CAISO 2016/17 Transmission Planning 11/16/16 Meeting: Stakeholder Comments

Submitted by	Company	Date Submitted
Sandeep Arora (sarora@lspower.com) (925) 201 5252	LS Power Development, LLC	12/1/16

Fig 1: PACI congestion and ATC limits

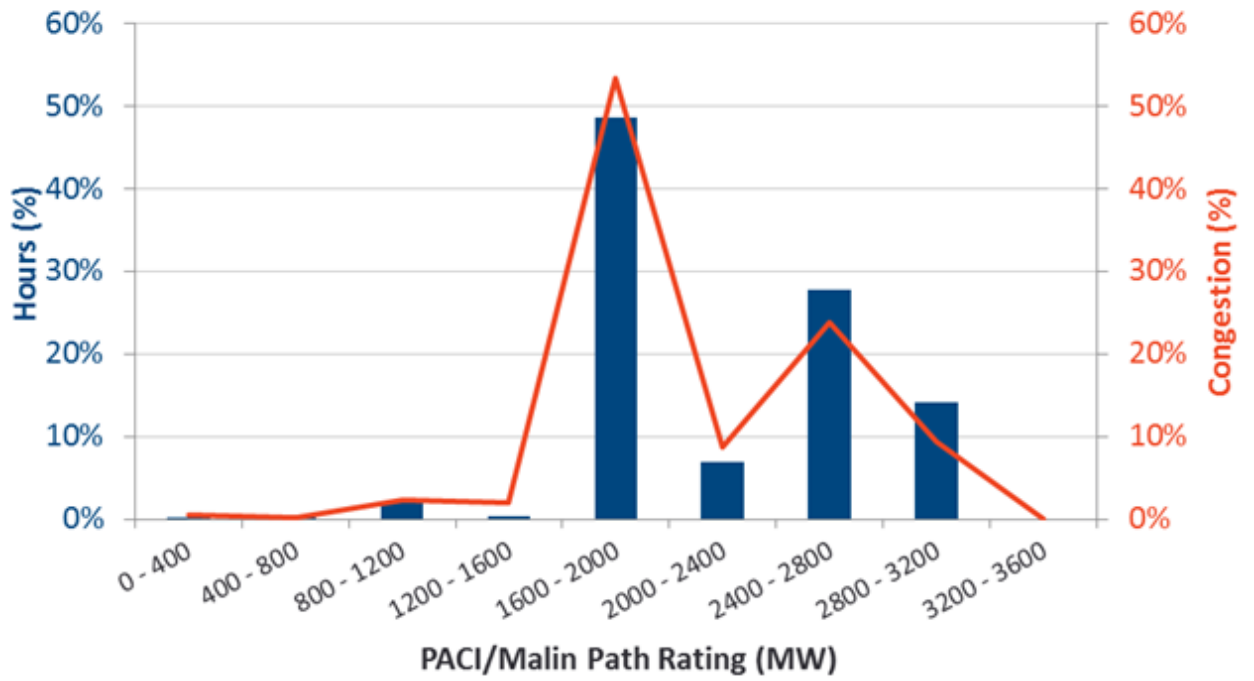
The COI path very frequently gets de-rated due to maintenance work. It is our understanding that a relay maintenance and replacement program has been underway for a number of years. This causes Transmission Owners to schedule outages of the transmission segments on the COI path and transmission segments adjacent to the COI path boundary. Every time a transmission segment is taken out of service, it causes de-rates on the COI path. COI de-rates lead to congestion in CAISO's Day Ahead and Real Time markets. We understand that CAISO is currently investigating this and intends to model these de-rates in economic studies. In support of our recommendation, we present the following data from CAISO OASIS for 2015. The chart below shows that the PACI path, which has a full rating of 3200 MW, was limited to between 1600 and 2000 MW for almost 50% of the time during 2015. Also shown on this chart is the congestion on this path. Most of the congestion, as expected, occurs when the Path gets de-rated.
